Groundwater Application Review Summary Form

Application # G- <u>18975</u>
GW Reviewer Jen Woody Date Review Completed: 6/25/2020
Summary of GW Availability and Injury Review:
Groundwater for the proposed use is either over appropriated, will not likely be available in the amounts requested without injury to prior water rights, OR will not likely be available within the capacity of the groundwater resource per Section B of the attached review form.
Summary of Potential for Substantial Interference Review:
$oxed{\boxtimes}$ There is the potential for substantial interference per Section C of the attached review form.
Summary of Well Construction Assessment:
☐ The well does not appear to meet current well construction standards per Section D of the attached review form. Route through Well Construction and Compliance Section.
This is only a summary. Documentation is attached and should be read thoroughly to understand the basis for determinations and for conditions that may be necessary for a permit (if one is issued).

TO:			Rights Sec						Date _		6/25/202	20		
FROM	:	Groun	dwater Sec	tion		Jen Woo	ody ver's Name							
SUBJE	CT:	Applic	cation G- 13	8975					ew of _n/a					
50202

Figure 3. Water-Level Trends in Nearby Wells

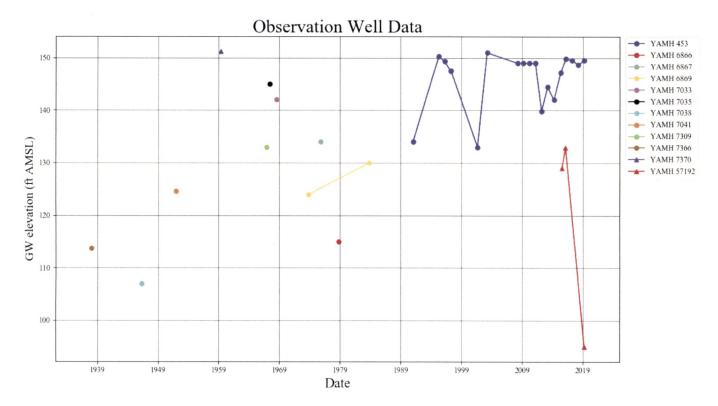
There are few nearby wells with time series groundwater level data available (see Figure 3). The limited capacity of the aquifer and the proposed rate indicate that water-level and water-use measurement conditions (item B1di above) should be included if a permit is issued by the Department.

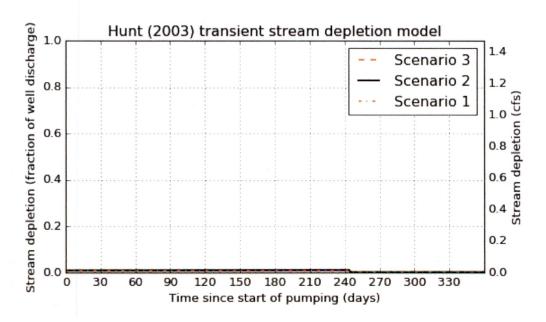
Comments: PSI is triggered because the proposed rate is greater than 1% of the instream right on Salt Creek. The rate would need to be lowered to 0.004 cfs to overcome PSI at the proposed wells. Alternatively the proposed wells would need to be moved outside of one mile from Salt Creek.

As shown in Figure 4, stream depletion at 30 days of pumping is much less that 25% of the pumping rate.
